Application for Permission under Section 16 of the Town Planning Ordinance (Cap. 131) for Proposed Temporary Centralised Quarters for Imported Labour in Construction Sector for a Period of 3 Years in "Industrial" Zone and Area Shown as 'Road' of Planning Area 36 of Hung Shui Kiu/ Ha Tsuen New Development Area (Planning Application No. A/HSK/628)

Submission of Further Information

Responses-to-Comments Table

Figure 1a Access to the Application Site from Public Road

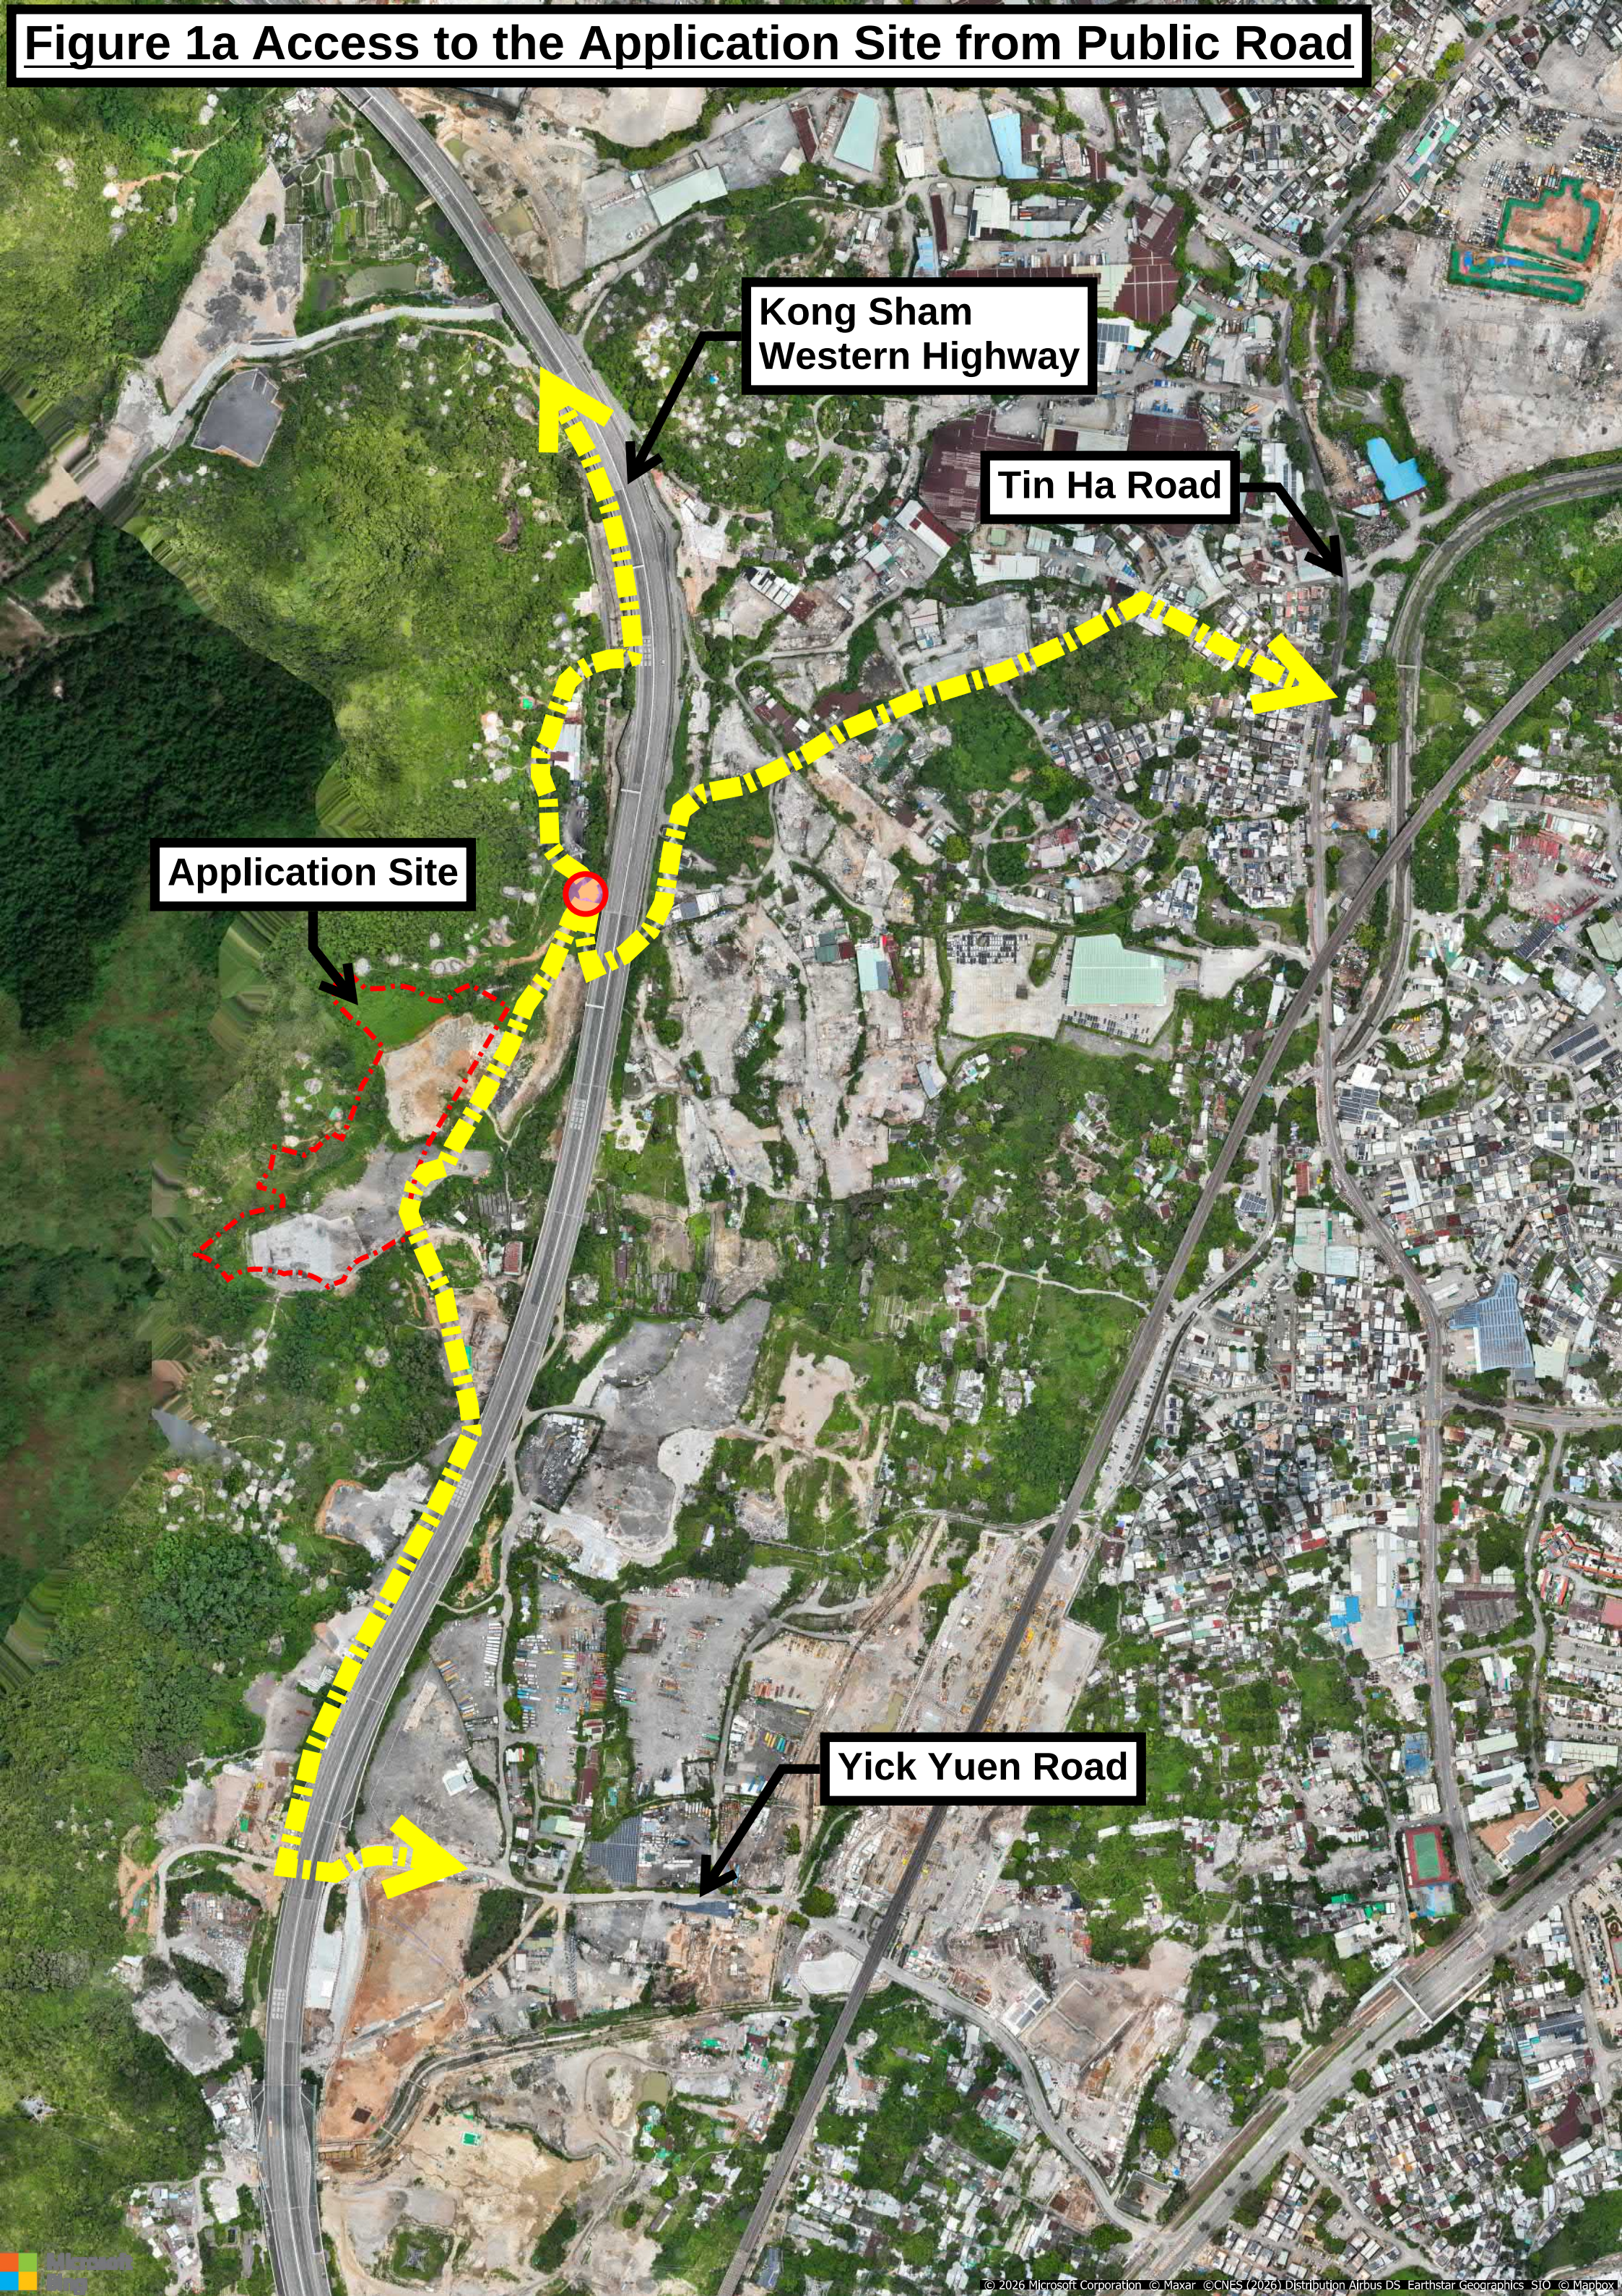
No.	Comments	Responses
1.	Lands Department, Lands Administration Office, District Lands Office, Yuen Long, dated 22 September 2026 Regarding the applicant’s responses on the accesses to Lot Nos. 1513RP and 3937RP, please advise and indicate the location of the existing accesses from public roads to be maintained to facilitate our consideration	Please find attached Figures 1a-1d indicating the access from the public roads to the concerned Lot Nos. 1513RP and 3937RP.
